8/9.9 FourStroke Fuel Pump Inspection

Models Covered	Serial Number
8/9.9 FourStroke	0R423736-0R425571

a - Green paint dot

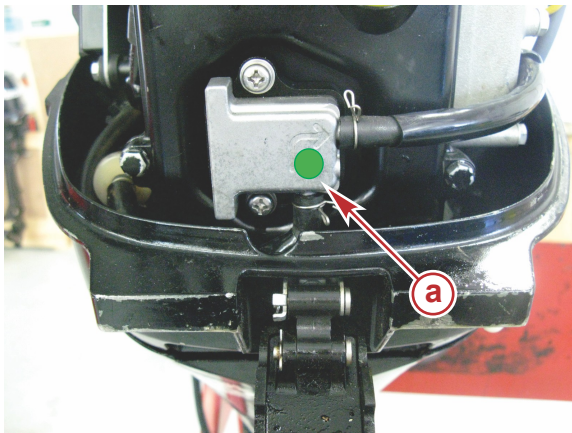
Mercury Marine has identified a performance issue with the fuel pump on the above listed outboards. The check valve seat located within the fuel pump could cause the performance of the fuel pump to diminish as the engine run time increases. It has been determined that all fuel pumps within the specified range should be replaced.

Fuel pumps that have been reworked at the factory will have a green paint dot on them. If your fuel pump does not have a green dot located on the fuel pump body, proceed to the correction procedure.

a - Green paint dot

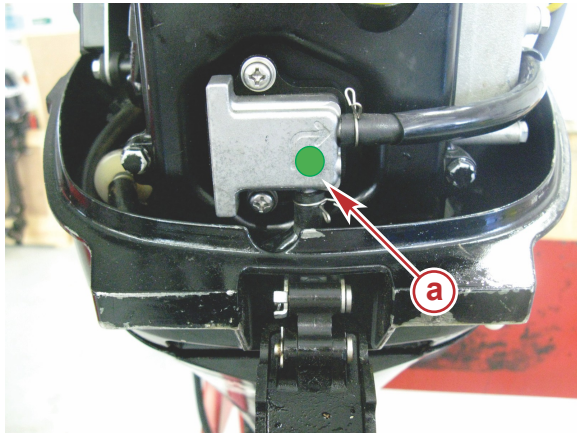
Outboards reworked at the factory, or by a Mercury Marine authorized dealer, will have a green paint mark on the lower right hand corner of the fuel pump, or a green dot on the boxing label located on the outside of the engine shipping container.

Follow applicable service manual procedures to replace the fuel pump assembly.
